# Planning Committee Addendum

#### **ADDENDUM**

#### PLANNING COMMITTEE

DATE: 19th January 2022

#### Figure 1 – comparison of previous and current layouts

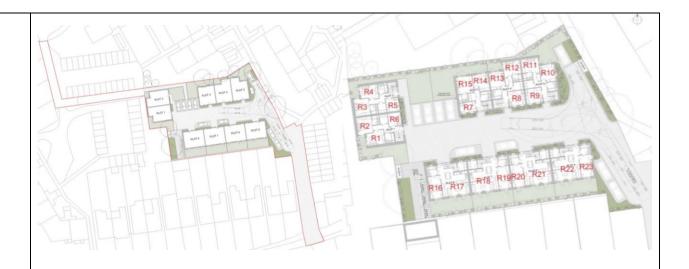
The proposed layout is broadly the identical to as the previous scheme under ref: P/0089/20, where the gap between building labelled Plot 1 and Plot 3 are increased with the omission of plot 2 and the proposed building footprint of Plot 1 has been increased with the addition of plot 2 with the building abutting the western side boundary from the 2019 scheme under planning ref: P/0898/19. The proposed building accommodating Plots 1 and 2 also maintains a similar set back from the northern boundary as the block accommodating Plots 3-5. The Therefore the layout is considered appropriate and it would be unreasonable to warrant a refusal on the basis of the Inspector's decision.

Figure 1 is amended as follows to reflect the previous appeal site layout.
